ExNB	Co-ordination of Notified Bodies Directive 2014/34/EU of the European Parliament and of the Council (ATEX) <i>Equipment and protective systems intended</i> <i>for use in potentially explosive atmosphere</i>	Clarification Sheet N° ExNB/CS/022
-------------	---	---

Cable entries according to 5.3 of EN 60079-1:2014

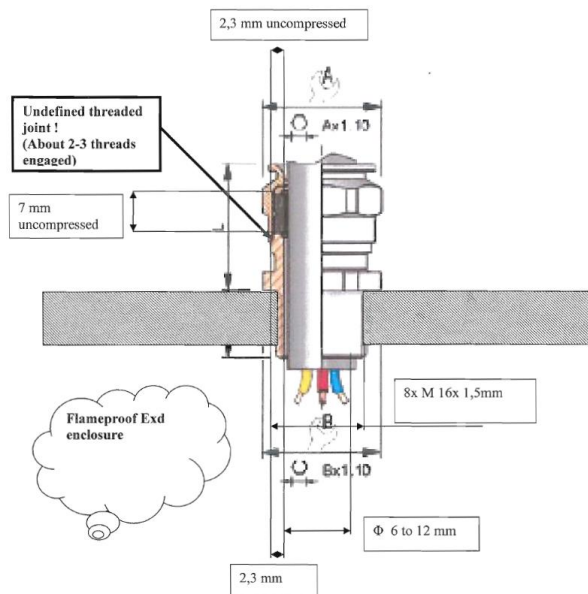
Question: Shall be the threaded joint between the body and cap of the cable gland in compliance with the Table 3 of EN 60079-1:2014 in the case of design mentioned in the picture (The dimensions shown in the drawing are incorrect.)?

Answer: Yes. The threaded joint is located before the sealing ring downstream of explosion and the tightness by the sealing ring cannot be defined as a flameproof joint. Hence, the mating threads between the male entry compartment and the femal backnut shall comply with the requirements of the Table 3 or 4 and shall be tested as flameproof joint. The seal on the cable will need to comply with Annex C. This answers was confirmed by the responsible Maintenance Team for the IEC 60079-1 during the MT-meeting in Melbourne 2011.
